**Attachment 4-10
Thermal Desorber Gas Burner Calculations**

**MIXED WASTE FACILITY
RCRA/TSCA PERMIT APPLICATION**

Concrete Containment Pads- Construction Certification Report

RE: CONCRETE CONTAINMENT PADS – CONSTRUCTION CERTIFICATION REPORT

Photo #4 – Yard Pad at Cut off Bollard

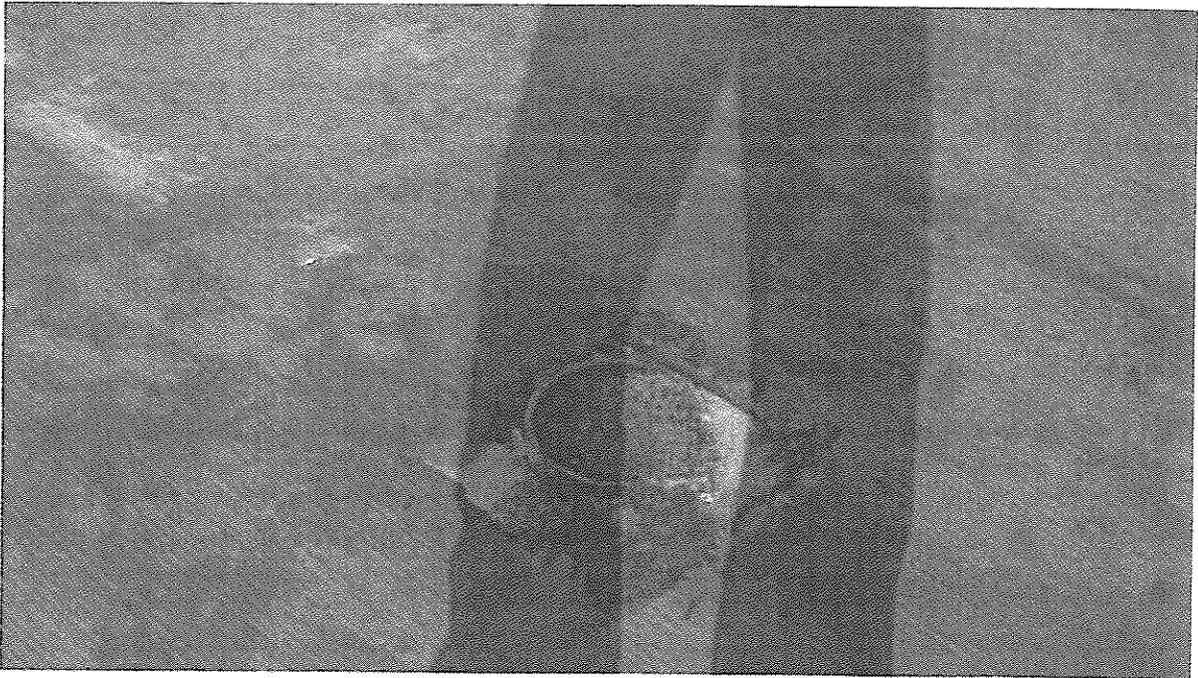
1. It appeared that a sealant coating had been applied to the entire pad surface.
2. The bollards were installed. Four (4) of the bollards had been cut down flush with the pad. There were some cracks around the base of these bollards.
3. Control joints had been cut into the slab. All joints had been sealed with what appeared to be an elastomeric sealant. The sealant appeared to be in good condition.
4. Expansion joints were located at the edges along the building doors and at the south ramp. The expansion joints appeared to have an approximately ¾" asphaltic material placed inside the joint.

1. Sealant coating shall be applied to all concrete surfaces.
2. All cracks in the concrete shall be sealed.
3. All control joints shall have an elastomeric sealant installed.
4. All expansion joints shall be sealed.

Photo #12 – Railroad Containment Pad at Cracked Curb

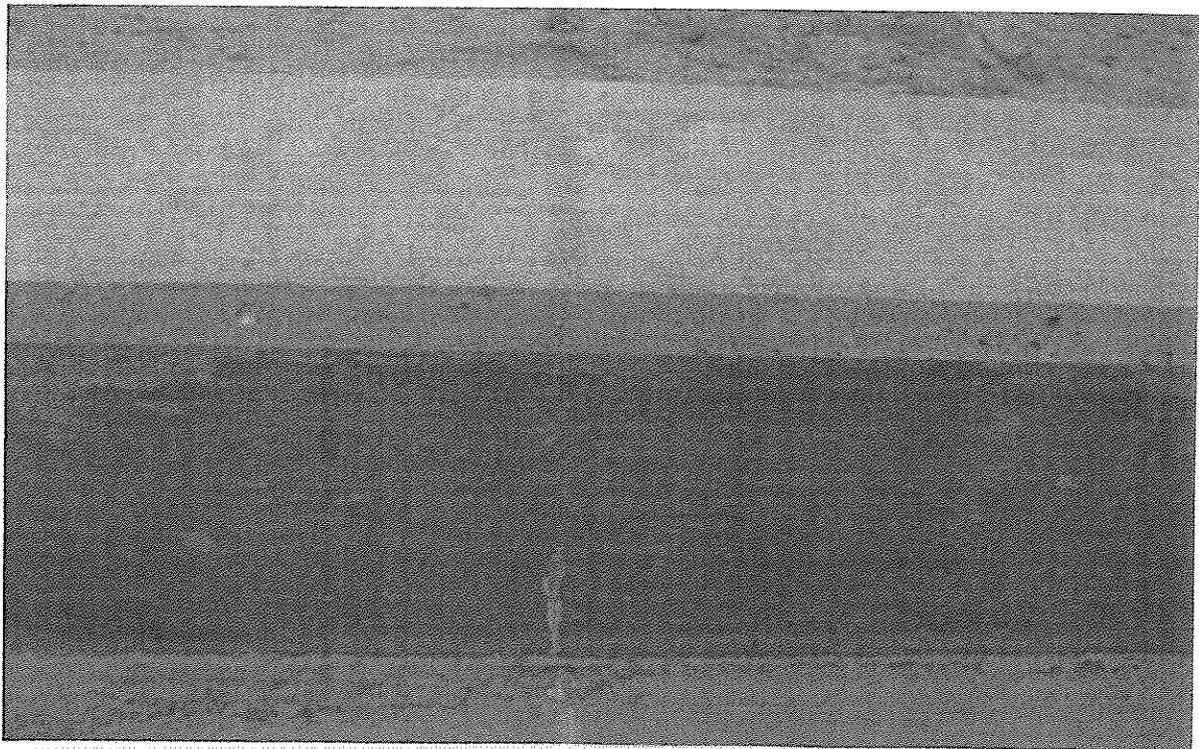
1. Only parts of the slab appeared to have a sealant coating applied on. Perma Fix stated that this was due to weather conditions and that sealant would be applied to the remaining un-coated surfaces.
2. Control joints were cut into the slab. Control joints had been partially sealed with what appeared to be an elastomeric sealant.
3. The built up 1'-6" thick x 9'0" wide pad was installed. Railroad rails had been installed on top of the built up pad.
4. The six (6) 6" diameter drainage pipes were installed.
5. The bollards were installed.
6. Two (2) hairline cracks were observed along the North side curb.
